**ANGEL PLACE  
LEVEL 8, 123 PITT STREET  
SYDNEY NSW 2000**

## **PP-2020-141: 173-179 WALKER STREET & 11-17 HAMPDEN STREET RESPONSE TO SUBMISSIONS**

**Figure 4:** The view sharing diagram as contained on page 36- Appendix A – Urban Design Report of the submitted documentation, illustrates that the majority of views from the Belvedere apartments are not affected by the proposed building envelope within the East Walker Street Precinct.

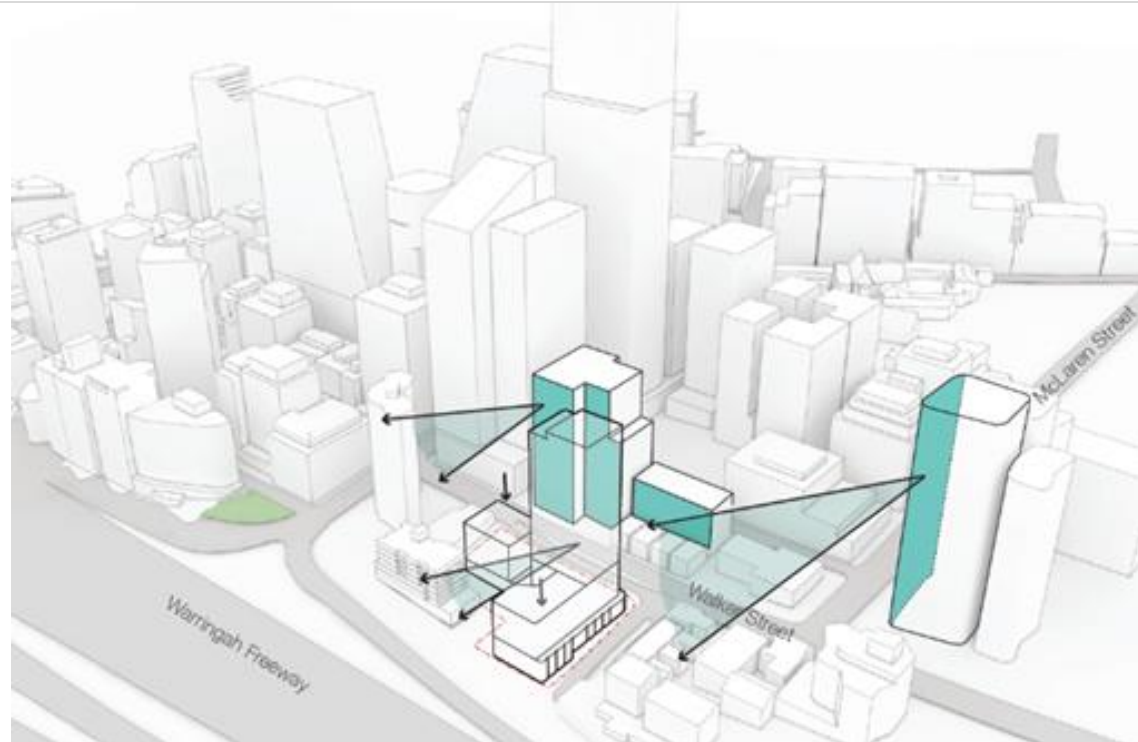
138 Walker Street Belvedere	Loss of views Use of online marketing material to make a vague assessment of	<p>The Belvedere apartments are located to the west of the site at 138 Walker Street. It comprises two tower forms. A southern tower of 20 storeys and a northern tower of 13 storeys, which is setback 20m from the Walker Street frontage.</p> <p>A review of the submissions confirms that the submitting parties have not properly reviewed the new revised building envelope for the site. In which, the building envelope shifts the tower form to the north with the specific objective of addressing their previous feedback. By shifting the built form north, this</p>

Issue	Objector	Relevant particulars	Response
		view affectations to Belvedere	<p>preserves the majority of views from the Belvedere tower, particularly those within the northern tower (<b>Figure 4</b>). A number of submissions have misinterpreted the Urban Design Package and raised objection against the '2019 special provisions scheme.' This scheme is superseded by the further developed and refined 'concept envelope' which specifically addresses this matter. Many of the concerns raised in those submissions have therefore been addressed by the outcomes of the concept envelope.</p> <p>Following the recommendations of the Sydney North Planning Panel and the Department of Planning, Industry and Environment (DPIE), the building envelope has been significantly revised to reduce the length of the tower form along Walker Street and in doing so, better promotes view sharing and enables view corridors through the site from the Belvedere apartments on the opposite side of the street.</p> <p>This has been achieved by creating two building forms, a reduced scaled slender tower within the north-western corner and a smaller building element to the south. The tower form is limited in footprint and from levels 9 -29, the built form is located wholly within lots at the corner of 11 Hampden Street and 179 Walker Street. At the ground floor – level 8, the built form has been split to create a 12m above podium separation distance. The break within the building envelope has been designed to retain views from the northern 13 storey building within Belvedere, across the site. This view corridor is evident in the draft building envelope plan (<b>Figure 5</b>) and also clarified by the location of building footprints in <b>Figure 6</b>. Aerial imagery and the location of the tower confirm that the tower is located to the north west of the Belvedere apartments and therefore, upper level views from these apartments would likely be retained.</p>
